PECO Energy Company
 Nuclear Group Headquarters
 965 Chesterbrook Boulevard
 Wayne, PA 19087-5691

April 29, 1994

Subject: Peach Bottom Atomic Power Station, Units 2 and 3
 Response to Request for Additional Information on Supplemental
 Response to Generic Letter 87-02, Supplement 1, "Verification of
 Seismic Adequacy of Mechanical and Electrical Equipment in
 Operating Reactors, Unresolved Safety Issue A-46."

Figure 1

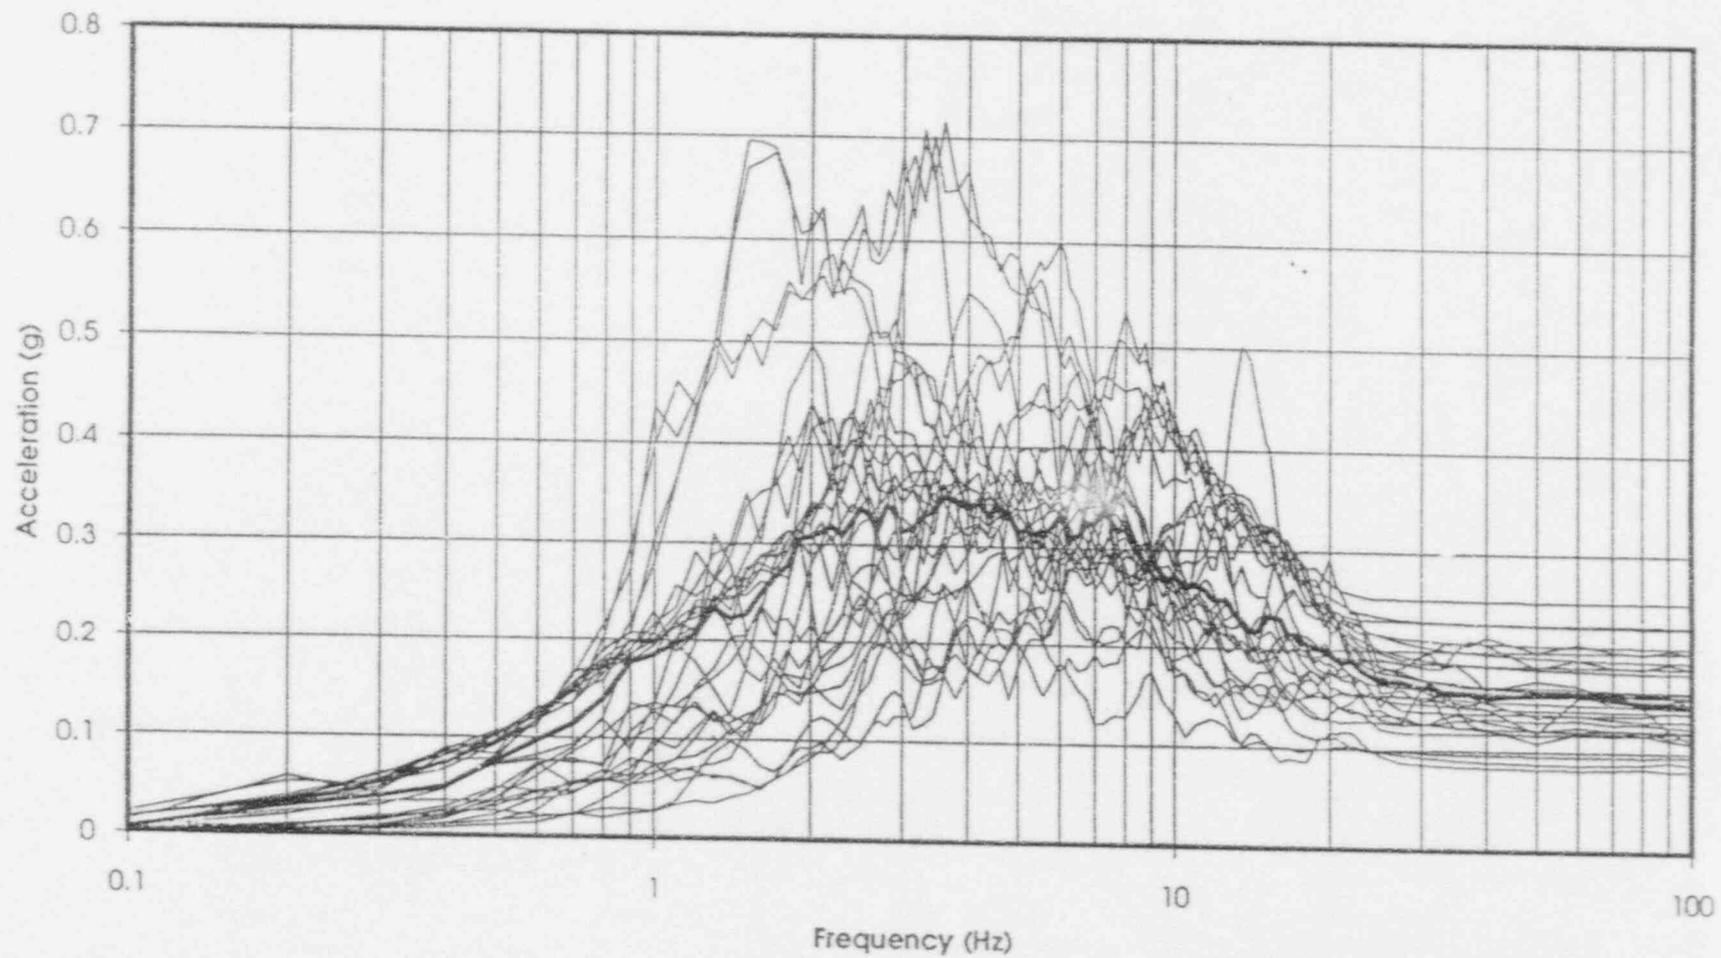
Question 1. Provide the details of the suite of earthquake acceleration time histories that will be selected from historical earthquakes or generated artificially, including their characteristics such as duration of strong ground motion.

Response 1. A suite of thirty different acceleration time histories were selected. The following information concerning these time histories is provided.

- Table 1 identifies the characteristics of the historical records which are part of the 30 records used in the time history analyses.
- Table 2 identifies the strong motion characteristics of all the time histories used in the time history analyses.
- Figure 1 is a plot of the 5% damped response spectra of all the 30 time histories and their median at all frequencies.
- Figure 2 is a comparison of the target NUREG/CR-0098 84th percentile spectral shape (anchored to 0.12g) and the median and 84th percentile response spectra obtained from the 30 time histories.
- Figure 3 plots the ratio of the 84th percentile spectral accelerations and the median spectral accelerations of the 30 time histories at all frequency ranges.

Figure 4 Radwaste Building Analysis Model (Y=West)

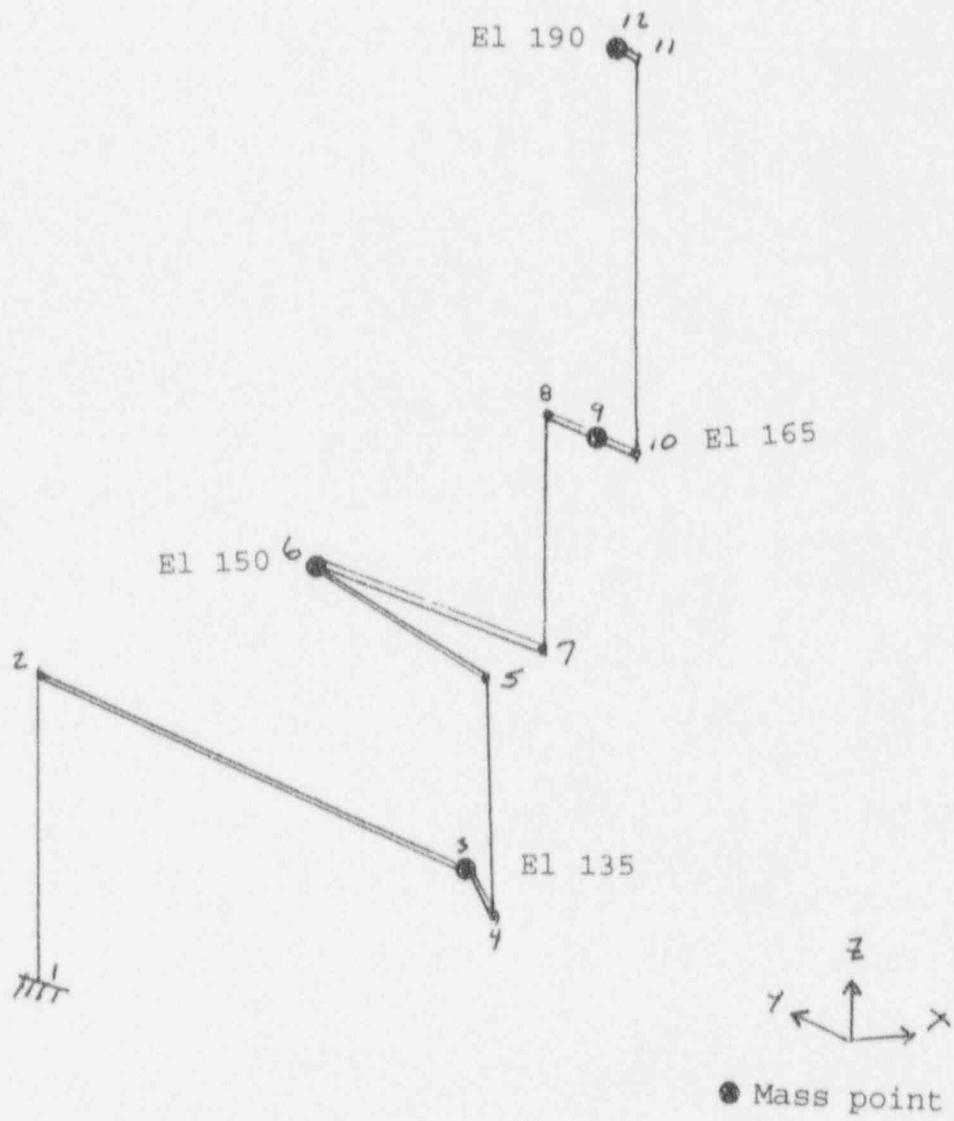
Question 2. Describe, in detail, the procedure used to develop the in-structure response spectra.

The structural model developed for IPEEE in-structure spectra generation is a full three-dimensional modeling, incorporating horizontal eccentricities between centers of mass and centers of rigidity at each major elevation. The analytical model is shown in Figure 4. The model has realistic concrete properties to account for concrete aging and stiffness reduction due to micro cracking. The median value for structural damping that will be selected for all modes of vibration will be 7% of critical damping.
